This narrative is a response to the September 2, 2009 Design Review Board comments for 1111 E Union St. Changes made to the previous design are highlighted in the packet in response to the following comments:

**DRB INITIAL RECOMMENDATIONS 09-02-2009:**

**1** NEIGHBORHOOD VERNACULAR - ELEVATION DESIGN PROGRESSION

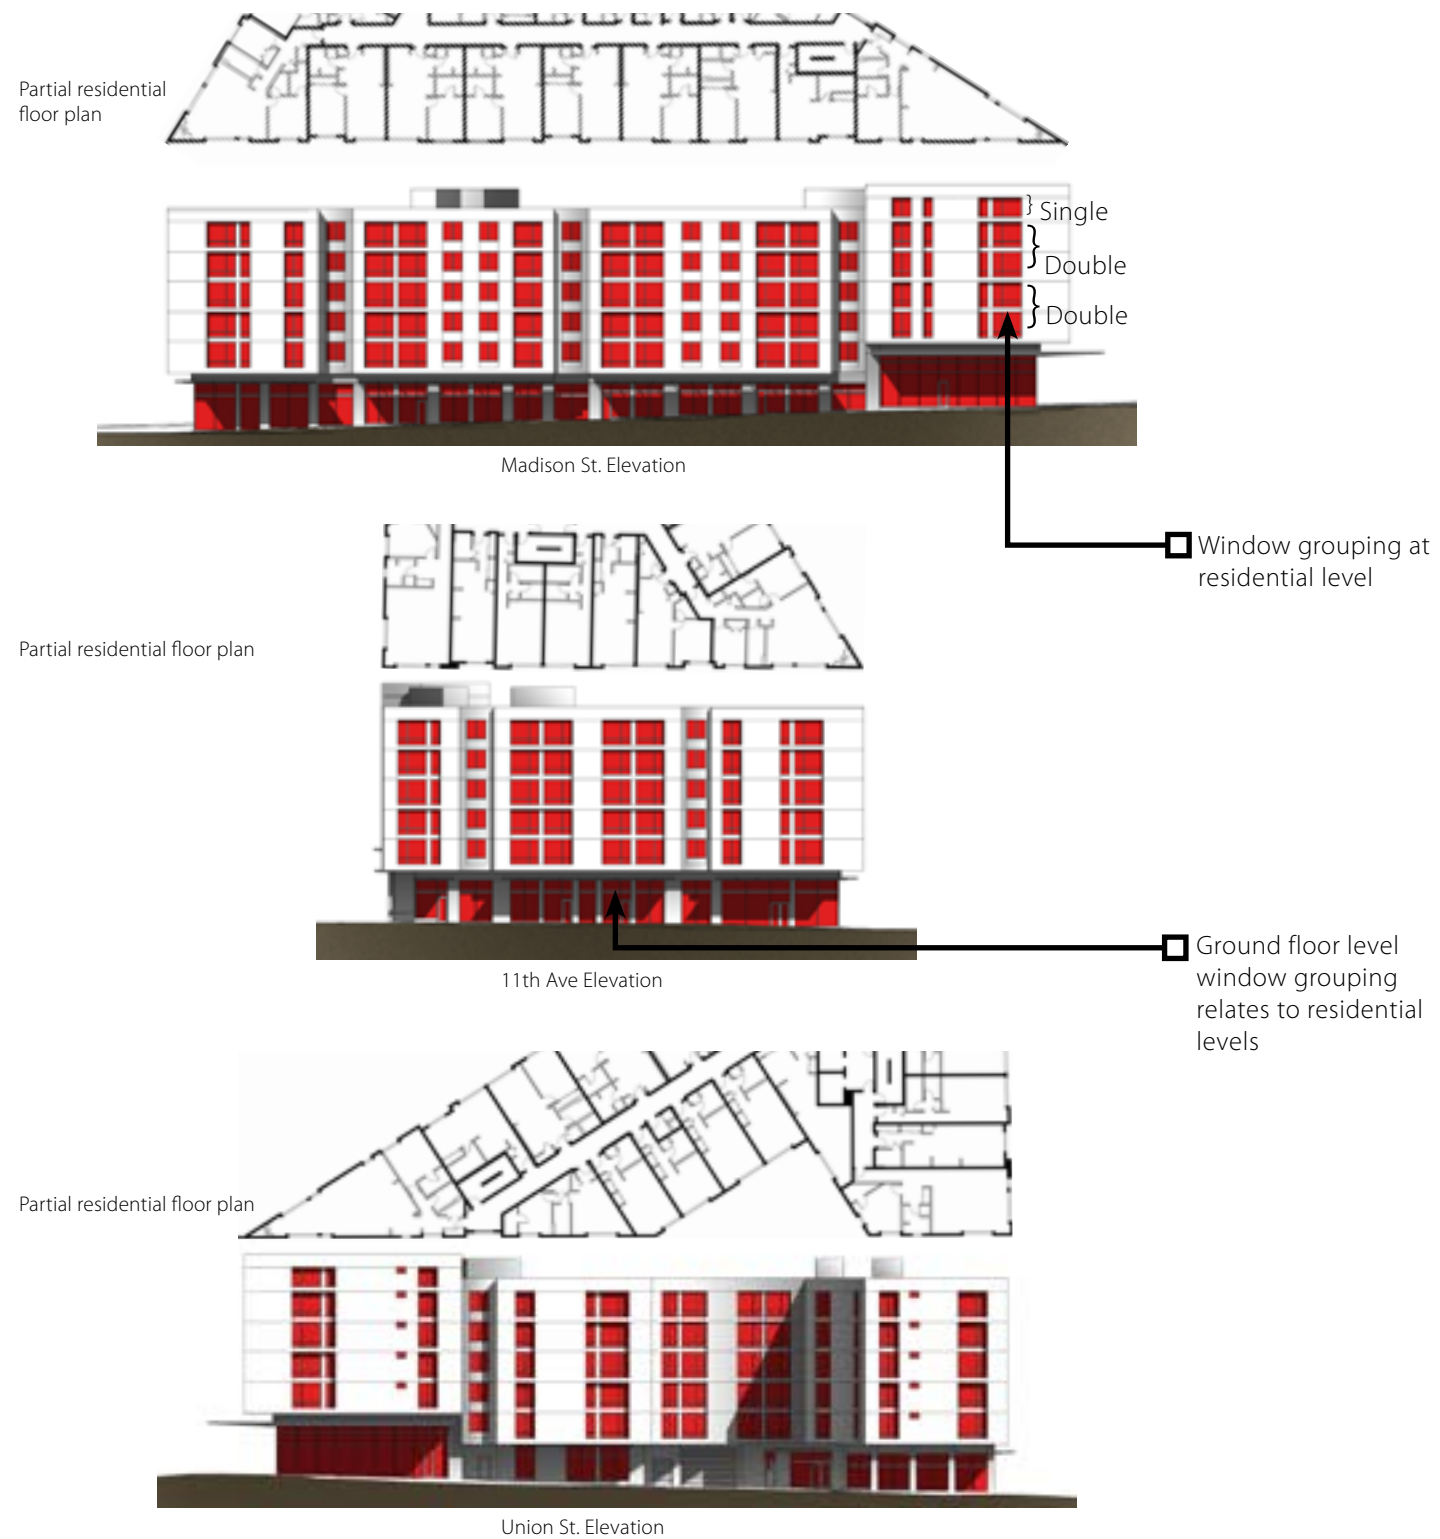
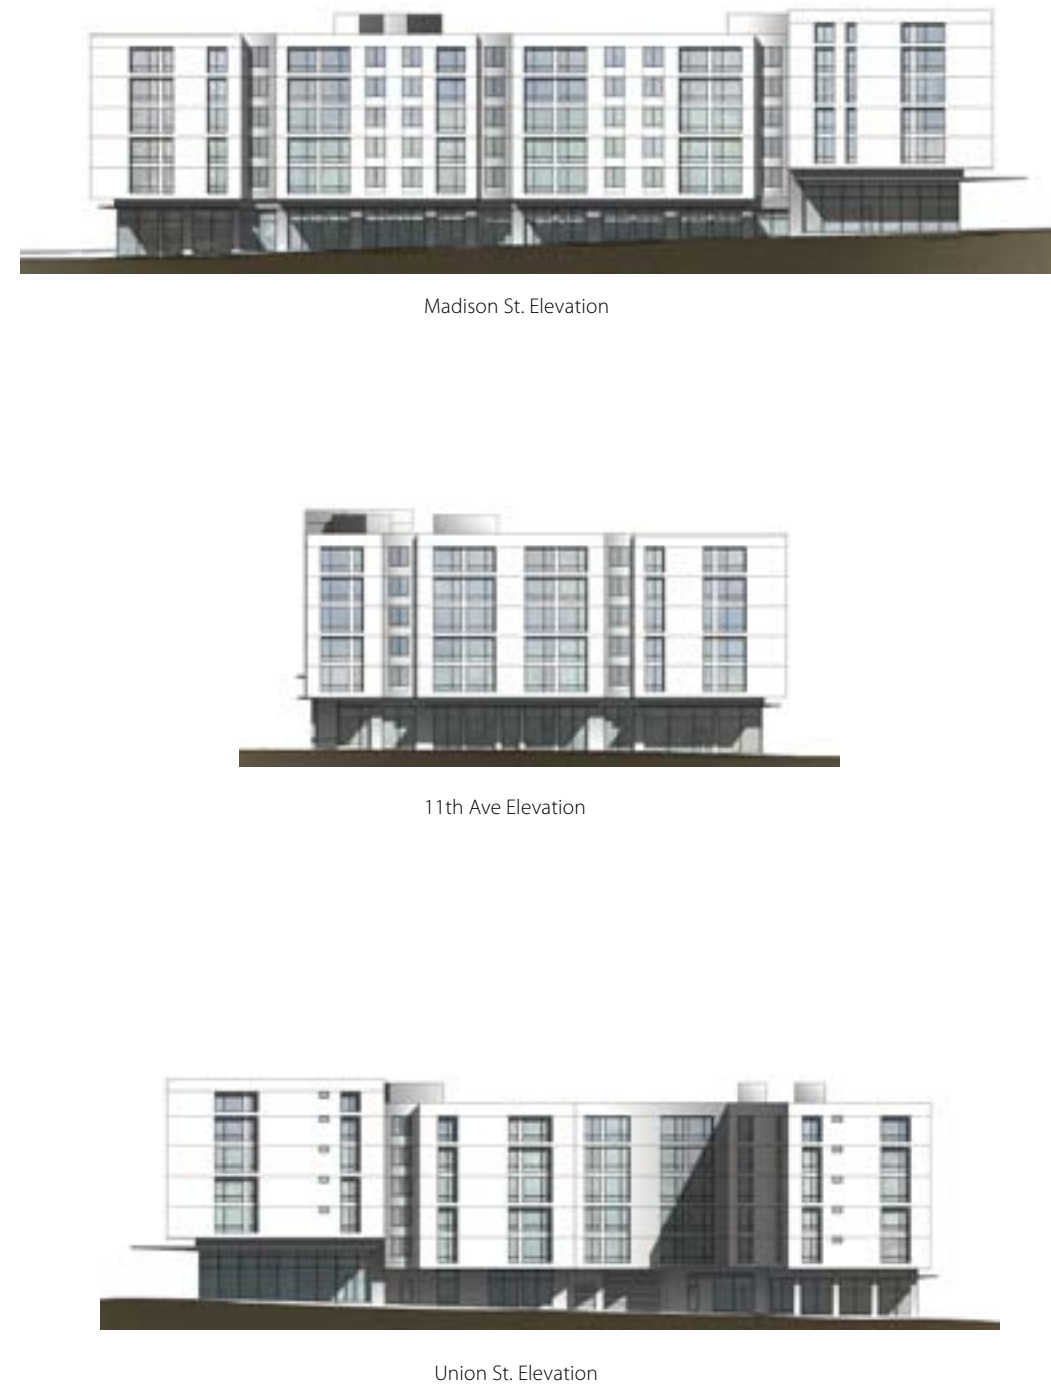
- 1** Design to be more attentive to the neighborhood vernacular.
- 2** Simplify the design and treat all 3 sides in similar consistent fashion.
- 3** Encouraged providing depth to the facades with the fenestration.
- 4** Encouraged warmer materials, especially at the pedestrian level.
- 5** Increase pedestrian safety at the plaza/driveway and bring the lobby closer to the street.
- 6** Provide greater detail at retail entrances, including weather protection, lighting and signage.
- 7** Provide views of building within Madison St. context.
- 8** Landscape plan could provide wider sidewalks and show proposed landscape plan at roof.

These studies show the design changes as window groupings and locations were adjusted to work with both the plan and the regular horizontal and vertical parts established by the building massing.

**1** Regular rhythm established with window groupings relates to the unit layout and to regular window bay patterns in contextual buildings. Rhythm of facade carried down to base of building.

**1** Massing and window studies (color and texture not shown for clarity)

## 2 SIMPLE CONSISTENT DESIGN ACROSS FACADES - PREVIOUS VERSION

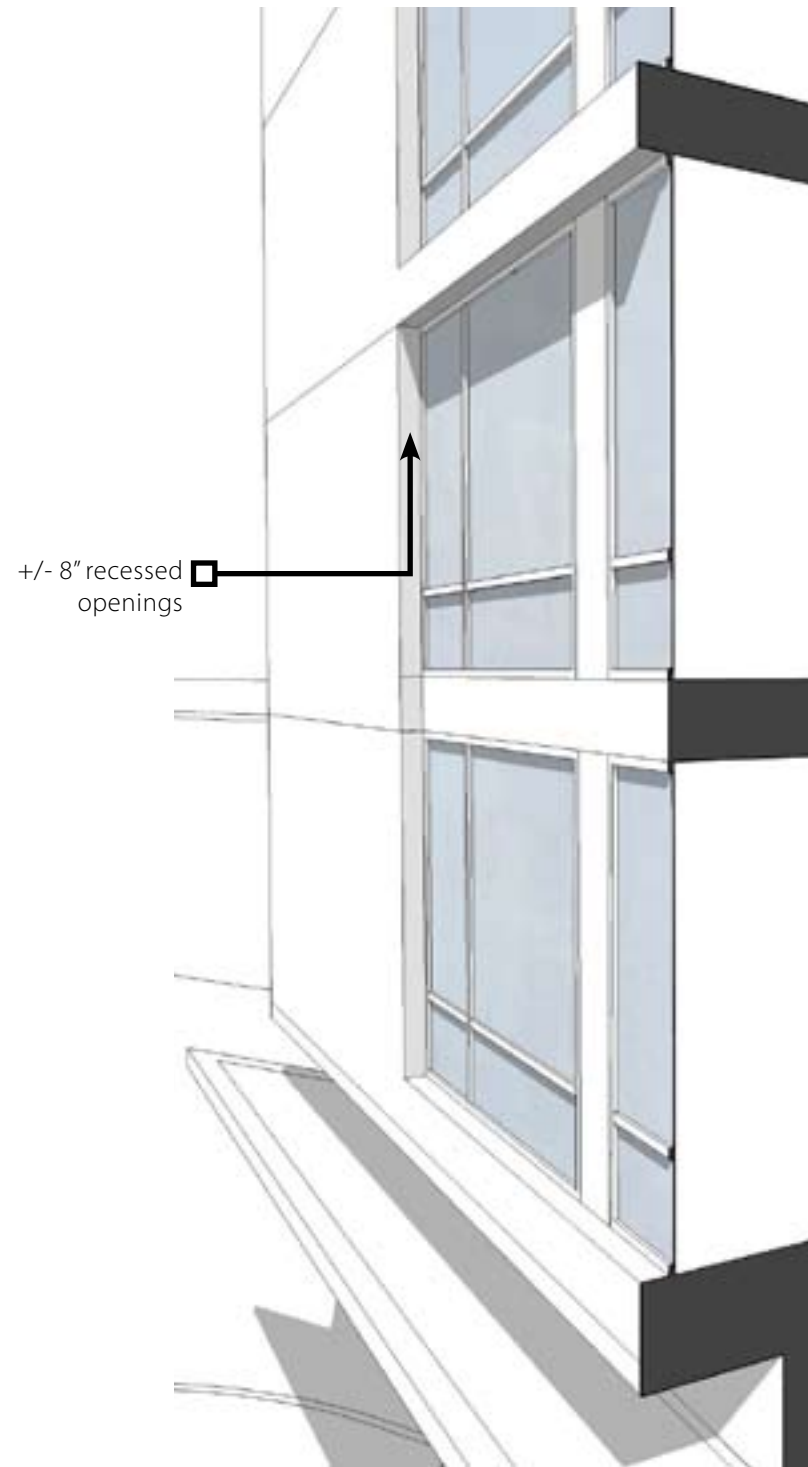
- simplify the design in a manner that is responsive to the neighborhood context
- did not recommend historical mimicry
- triangular shape of site and location on Madison makes design dynamic enough, additional modulations and gestures further complicate the design
- provide depth to the 3 facades with the treatment of the fenestration
- use of materials should follow the rhythm of the building form in a systematic & patterned manner
- would be supportive of the prow feature if it is consistent with the overall design approach throughout the rest of the building

- Elevations revised to apply window grouping consistently across 3 facades.
- The massing bays used in previous design have been removed.
- Relief along facade is provided with recesses at specific points as well as deeper punched openings.
